## Code Modification or Alternate Request

**Subject: Bridge Way Exhaust Code Variance**

**3825 BRIDGE WAY NORTH**

Subject: Code Alternate Request  
3825 Bridge Way North  
DPD #6574184

1 TYPICAL STUDIO UNIT  
A601 SCALE: 3/8"=1'-0"

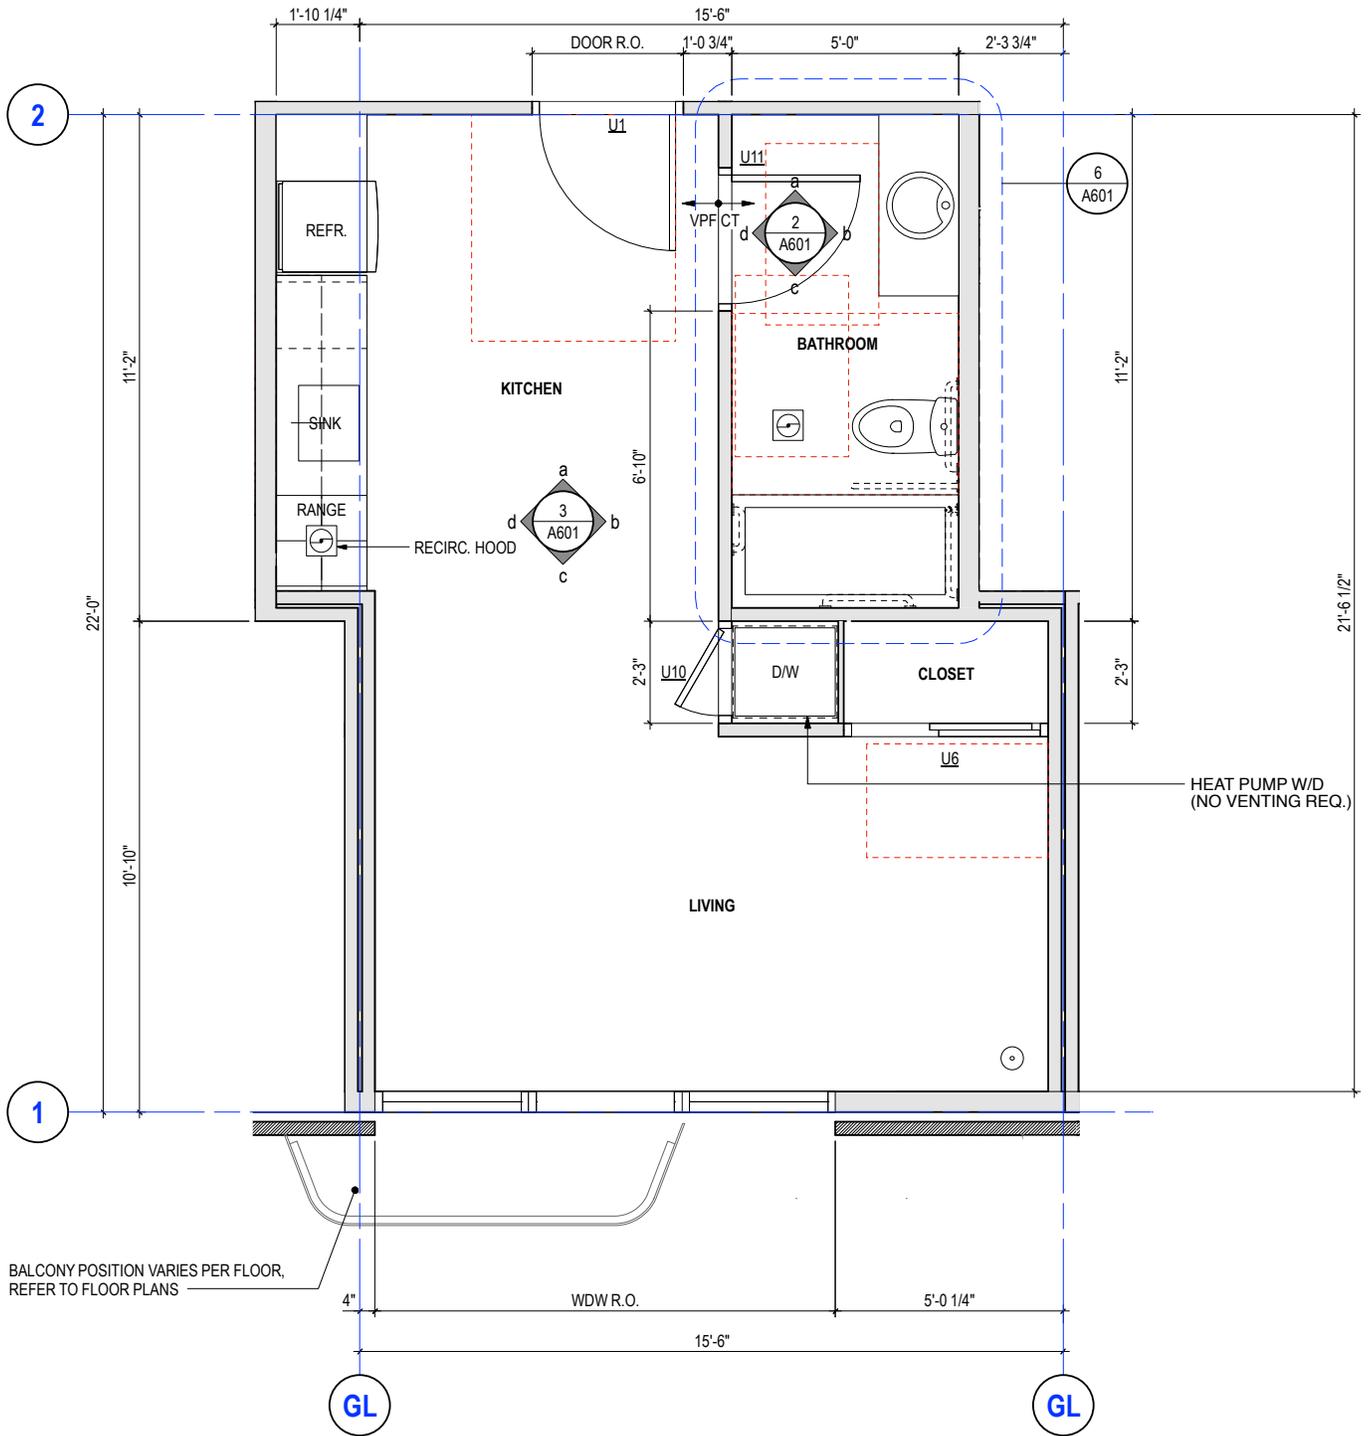
We request that the Authority having Jurisdiction (AHJ) allow us to use this approach. We will exhaust the apartment restrooms continuously at a rate of 30 CFM. We will transfer 30 CFM of air from the kitchen/living area to the restroom. We will continuously supply 30 CFM of outside air from a heat recovery ventilator to the living area. This will effectively result in the kitchen having a continuous exhaust rate of 30 CFM (to the bathroom) and the bathroom having continuous exhaust rate of 30 CFM. The effective air change rate for the spaces will range between 0.37 and 0.65 air changes per hour.
